New Reactors Division

Step 4 Assessment of Severe Accidents for the UK Advanced Boiling Water Reactor

Assessment Report: ONR-NR-AR-17-015
Revision 0
December 2017

Figure 2: Section through pedestal wall

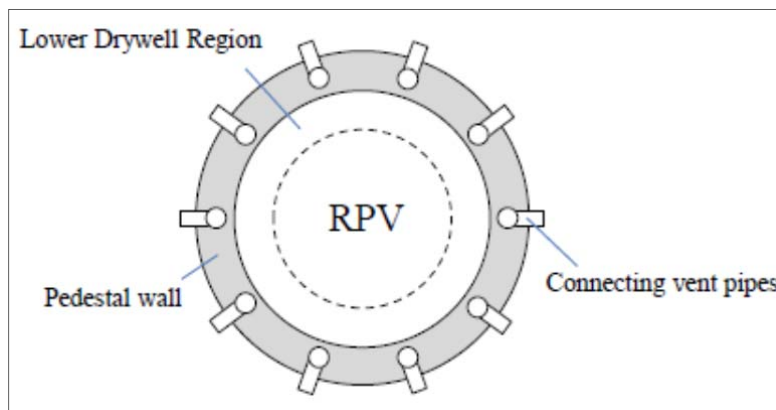
199. A horizontal cross-section through the concrete pedestal wall is shown in Figure 2. Corium spreading on the LDW floor would initially impinge the inner steel plate of the pedestal wall. Hitachi-GE's results show that it typically fails within less than 30 minutes after contact with the corium. Hitachi-GE assumes that the loss of the inner steel plate does not affect the overall integrity of the pedestal wall, although this is not discussed explicitly in the safety case. After the inner steel plate fails, the bulk concrete of the pedestal wall is ablated. The concrete of the pedestal wall is assumed to have no load-bearing function in the Civil Engineering safety case. Hitachi-GE assumes that the load-bearing function of the pedestal wall is maintained by outer steel plate until ablation has progressed radially through 90% of the thickness of the concrete. At this point, Hitachi-GE claims that the temperature rise of the outer steel plate of the pedestal wall cause the plate to lose its load-bearing capacity, resulting in collapse of the pedestal wall and failure of the containment due to loss of support to the RPV. After consultation with ONR's Civil Engineering inspector, I consider that Hitachi-GE submissions (Ref. 44 & 83) do not provide evidence to justify why integrity is maintained up to this point.

200. Figure 2 also shows the vent pipes which are positioned in the pedestal wall about 25 cm from the inner steel plate. Modelling of the behaviour of the corium and MCCI in such geometries is beyond the capability of existing severe accident codes. Hitachi-GE argues that it is not necessary to consider the presence of these pipes because the
